Model: Triton-C1 E750 Controller		Date: 29-Jul-04	No.: MB728001
Modified Article: Parts Catalog Correction		Prepared by: Y. Ohtani	
From: 1st Tech. Support Sec. Service Support Dept.			
Reason for Modification:	<input checked="" type="checkbox"/> Parts catalog correction <input type="checkbox"/> To facilitate assembly <input type="checkbox"/> Part standardization	<input type="checkbox"/> Vendor change <input type="checkbox"/> To improve reliability <input type="checkbox"/> Other	<input type="checkbox"/> To meet standards ()

Model: Triton-C1 EFI Controller	Date: 28-Oct-04	No.: MB728002a
---------------------------------	-----------------	----------------

Model: Triton-C1 EFI Controller (E-750)	Date: 12-Jan-05	No.: MB728003
---	-----------------	---------------

Model: Triton-C1 EFI Controller (E-750)		Date: 12-Jan-05	No.: MB728004
Modified Article: Interface Board for E850		Prepared by: M. Tsuyuki	
From: 1st Tech. Support Sec. Service Support Dept.			
Reason for Modification:	<input type="checkbox"/> Parts catalog correction <input type="checkbox"/> To facilitate assembly <input type="checkbox"/> Part standardization	<input type="checkbox"/> Vendor change <input type="checkbox"/>

Modified Article: Fan Motor

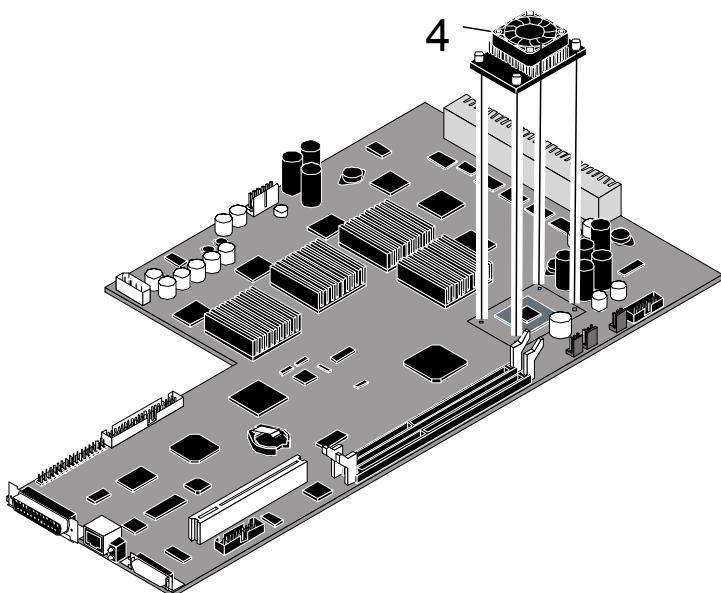
Old part number	New part number	Description	Q'ty	Int	Page	Index
B7285011	B7285061	Fan Motor (E0-07104000) Fan Motor (G0-00353000)	1	X/O	3	4

Change: The material of the mounting screw was changed from plastic to metal.
Reason: To attach the fan motor to the controller board more securely.
